ADDENDUM NO. 03

Northland Corridor Redevelopment Project Phase 4
631 Northland Ave.
Buffalo, NY 14211

Project No. 432607

Project Northland Corridor Redevelopment Phase 4 (BUDC) Addendum No. 3
631 Northland Avenue, Buffalo, NY Contract -
Wendel Project No. 432607 Date 10/22/25

DETAILS

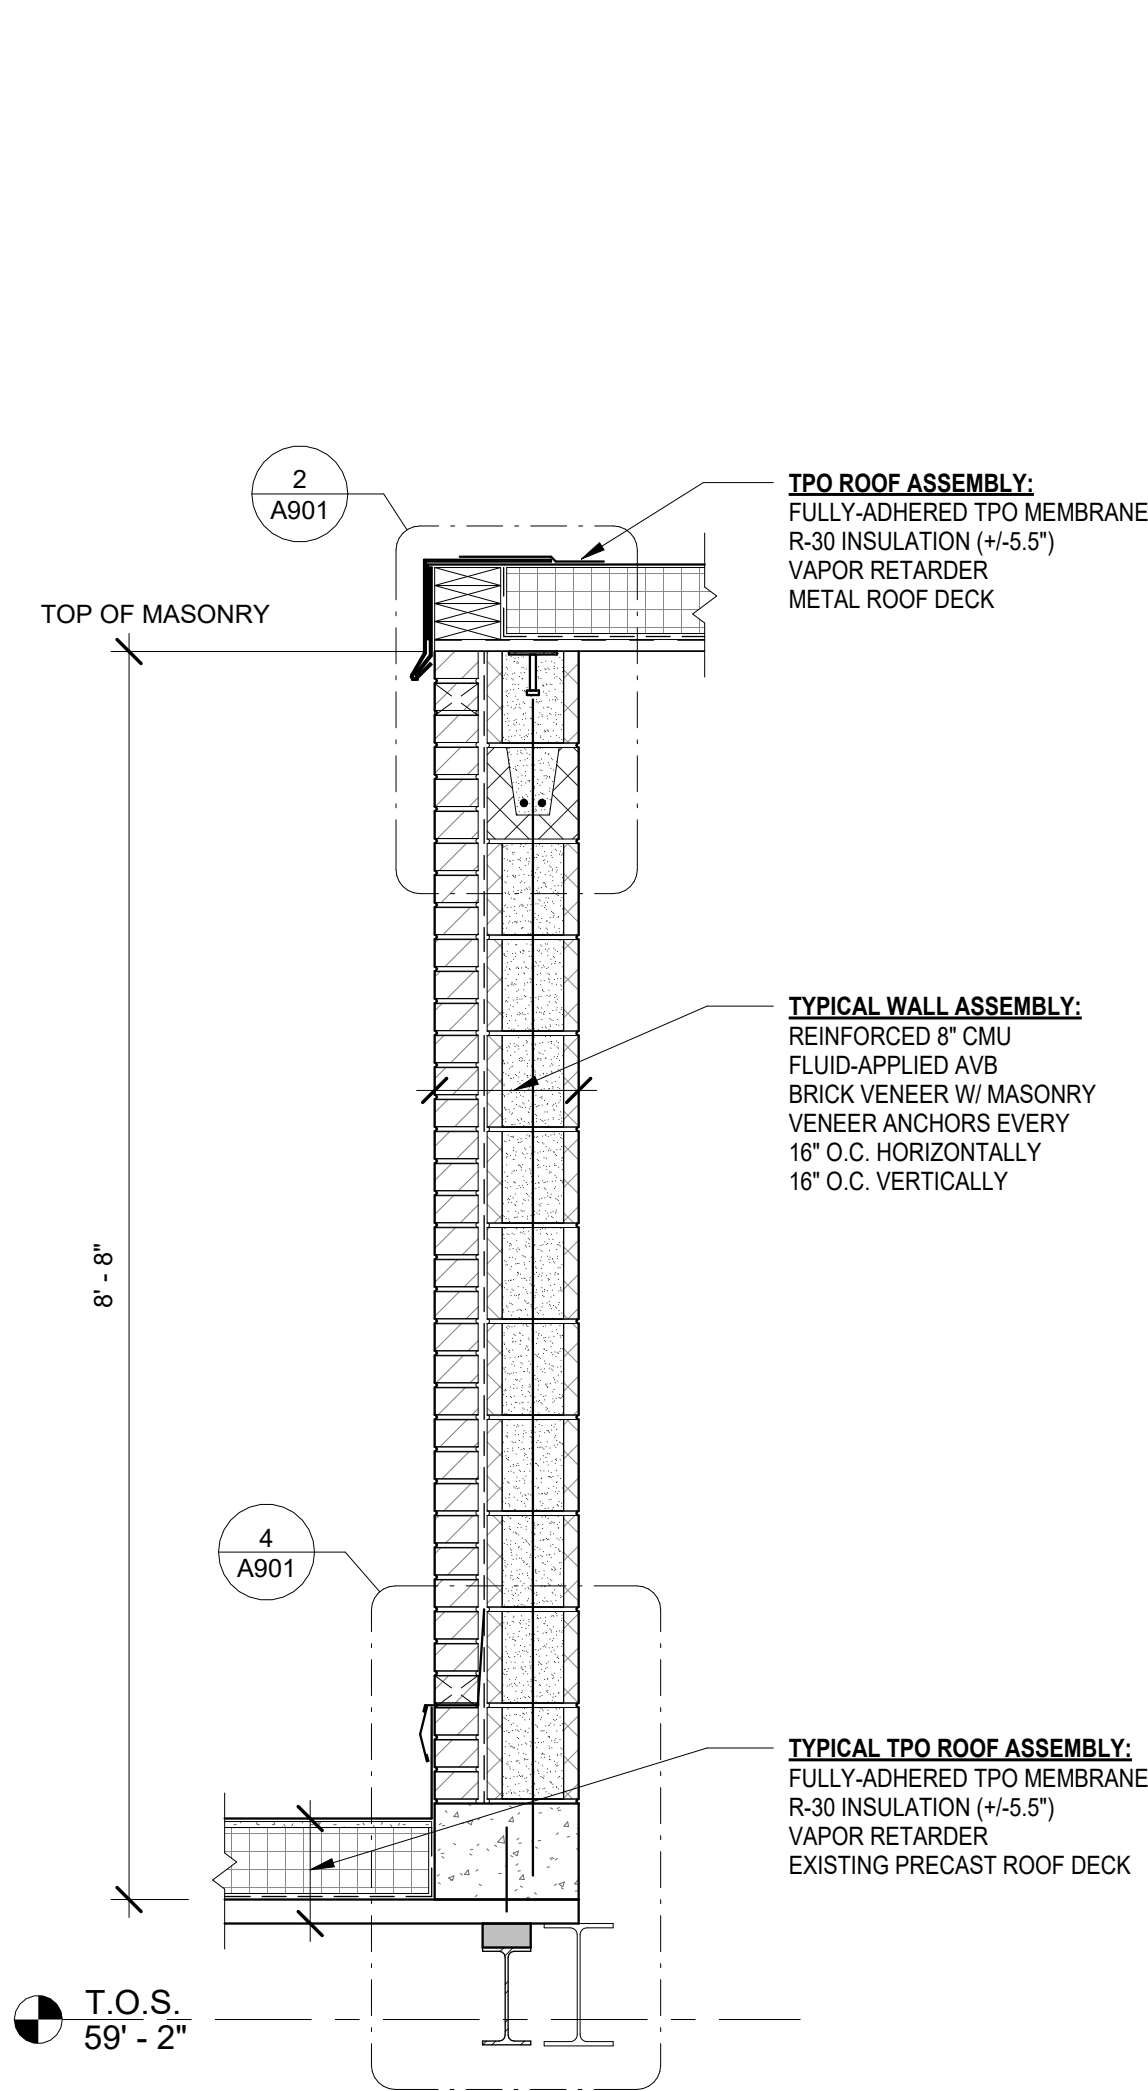
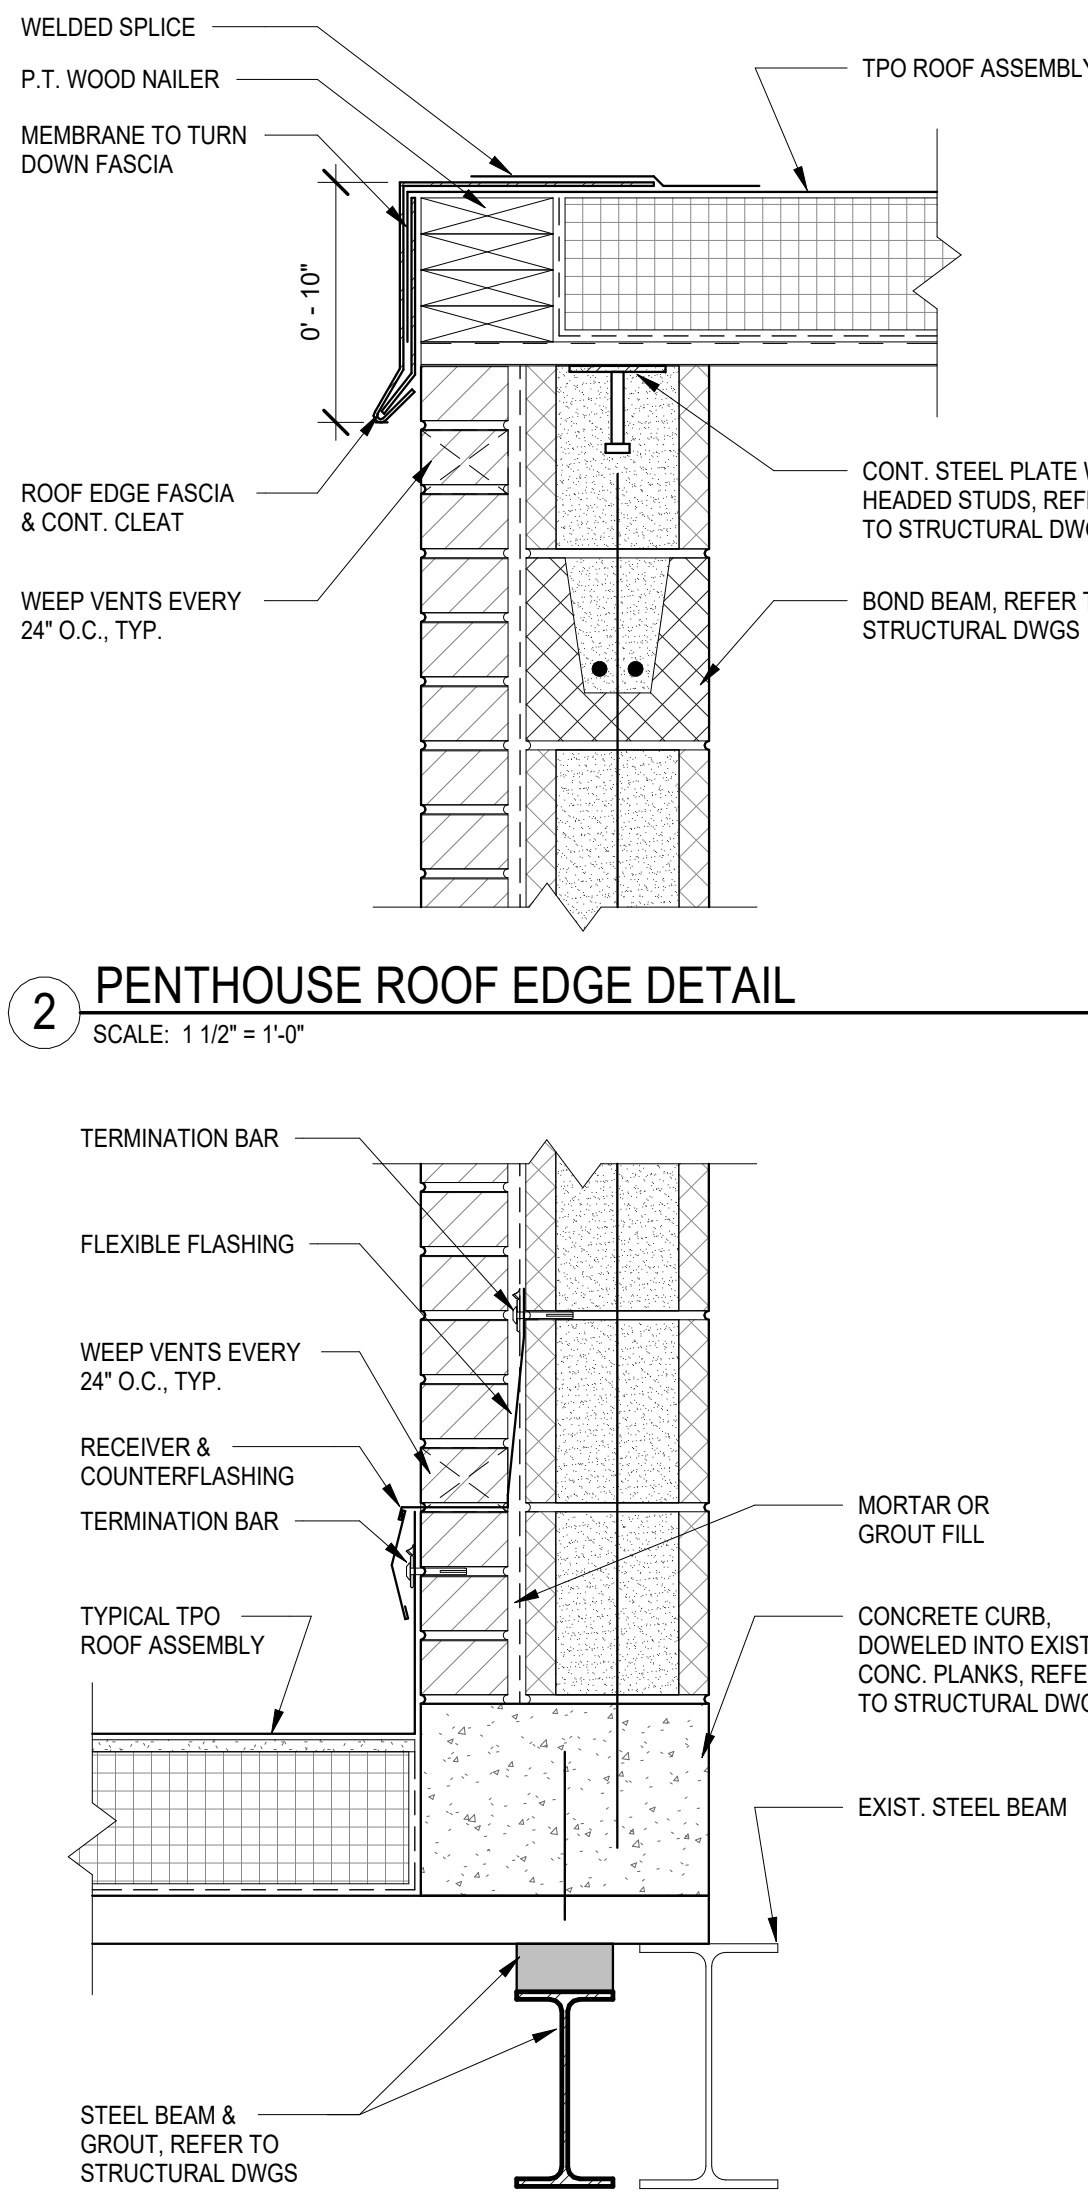
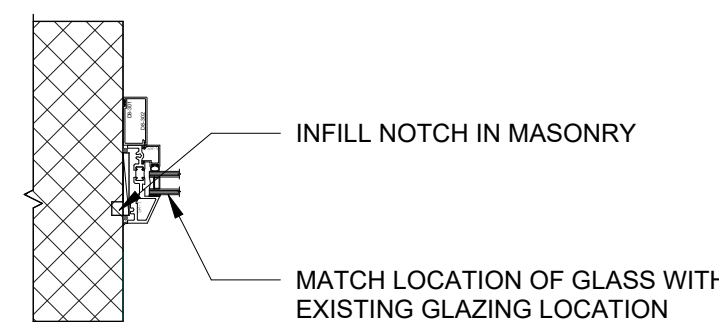
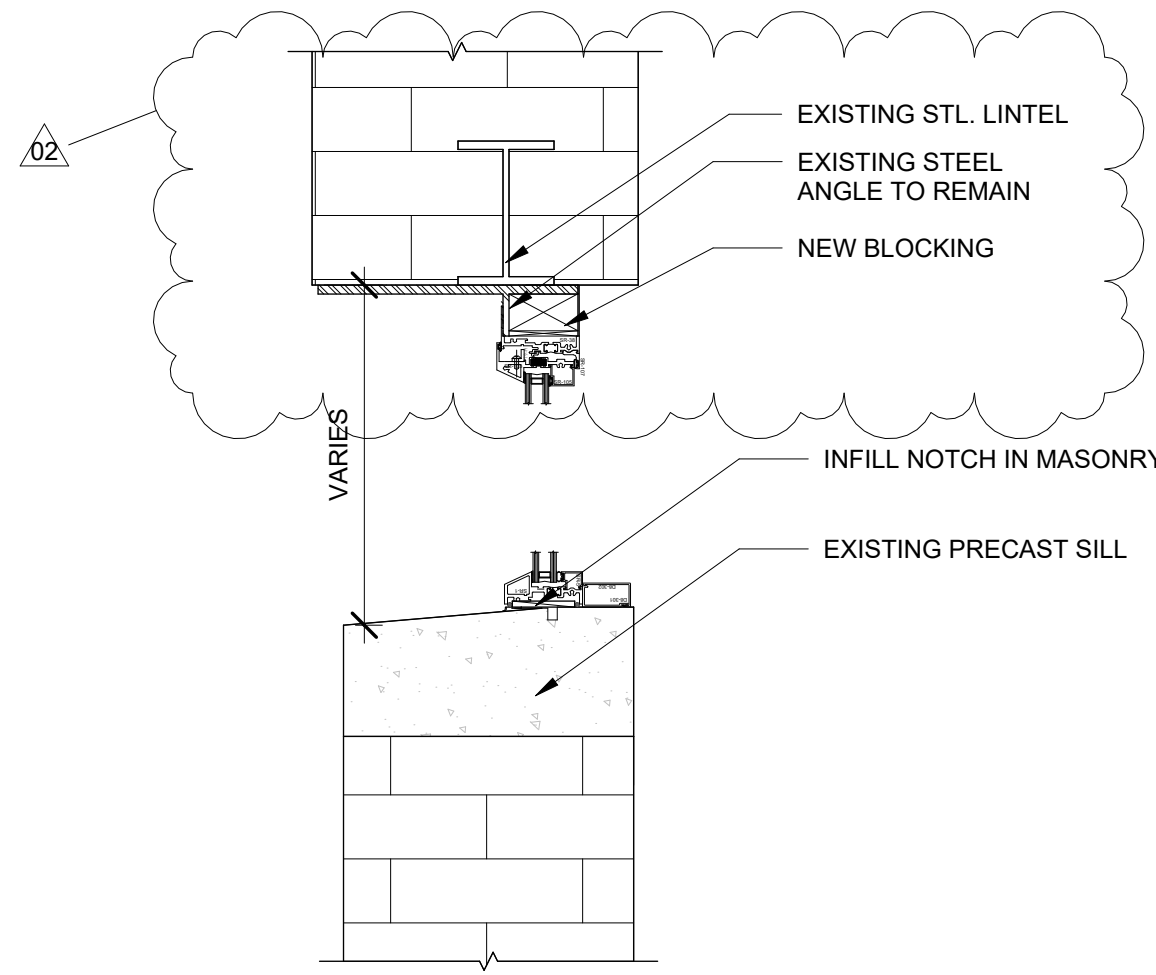
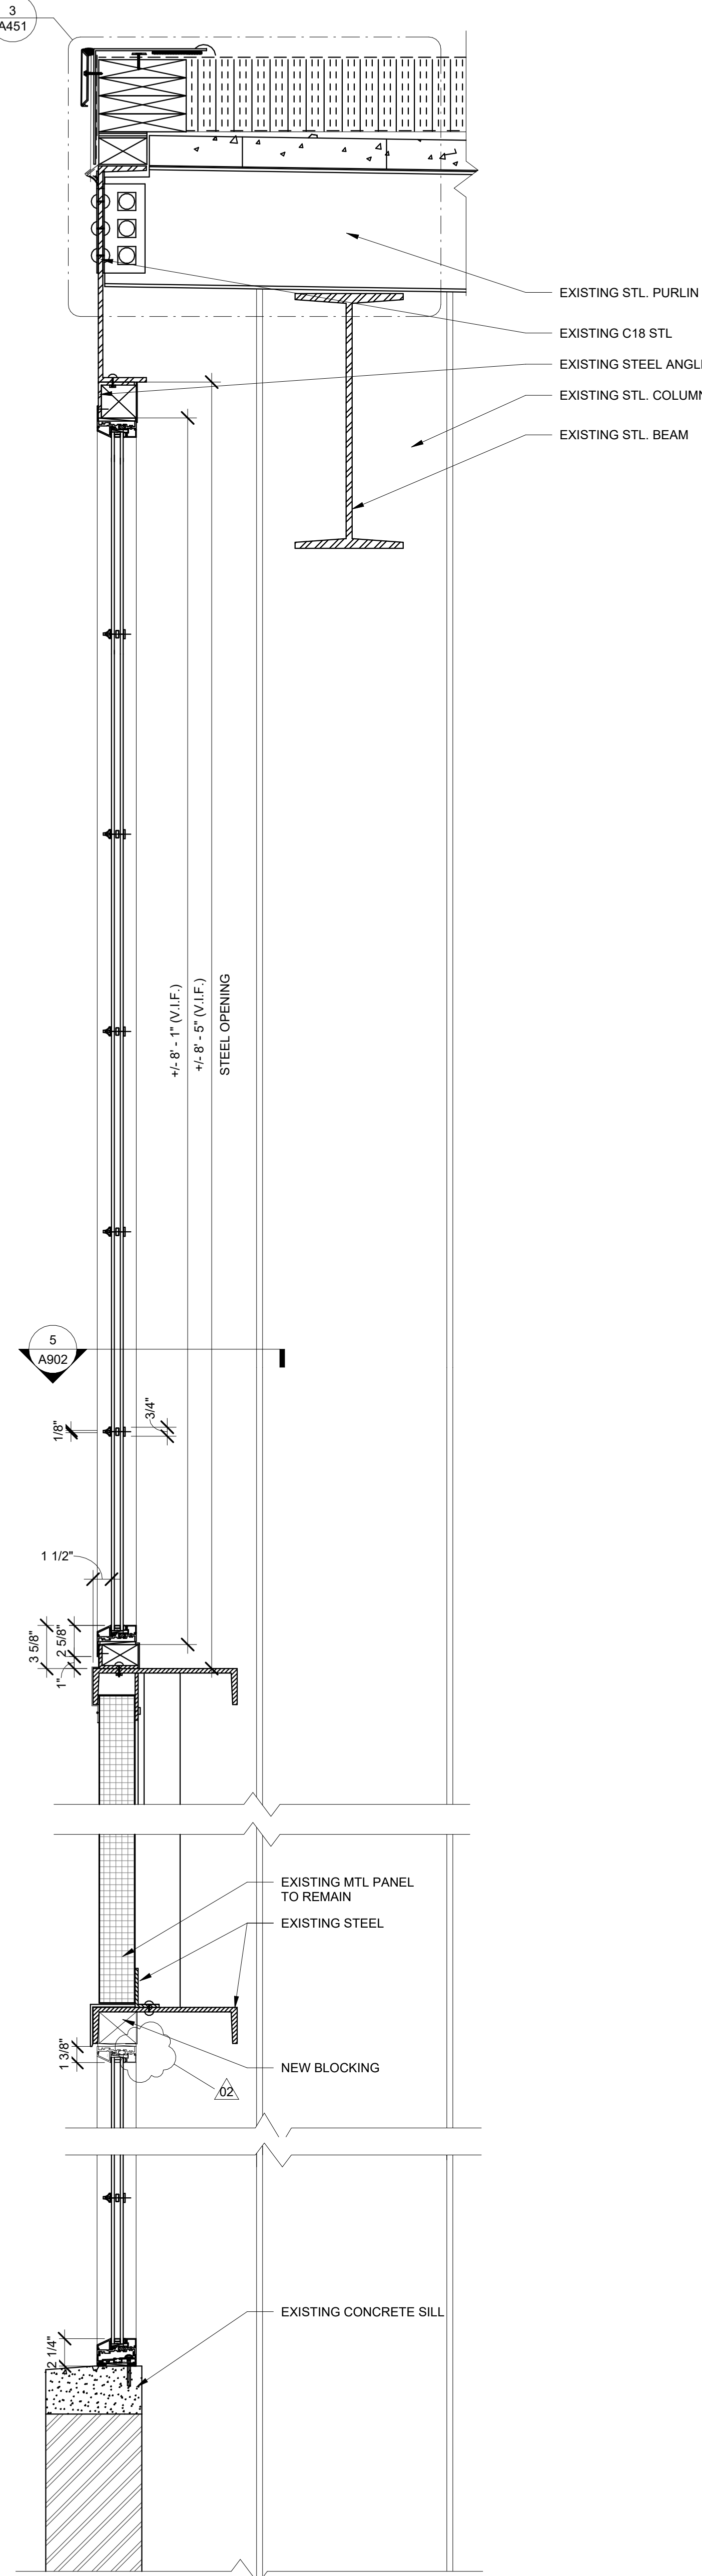
1. Door hardware is in Section 087100 which was inadvertently omitted from the original spec. Refer to specification Section 087100 attached to this addendum.
2. Drawing sheets A301 and A900 were revised and issued under Addendum 02.
3. Please refer to window elevations and coordinate with schedule. Please ask specific questions if contractor(s) are unclear on anything further.
4. Refer to revised drawing A901 removing snap trim from windows. There should be no snap trim.
5. Refer to revised drawing A901. SHPO & NPS final approval on windows are pending the window mockup in process. Contractor and awarded window manufacturer are responsible for verifying in field and confirming details via shop drawings. Design intent is that windows shall receive wood blocking where the head and/or sill have steel angles present.

REPLACE: Drawing sheet A901 with the revised issued in this addendum.
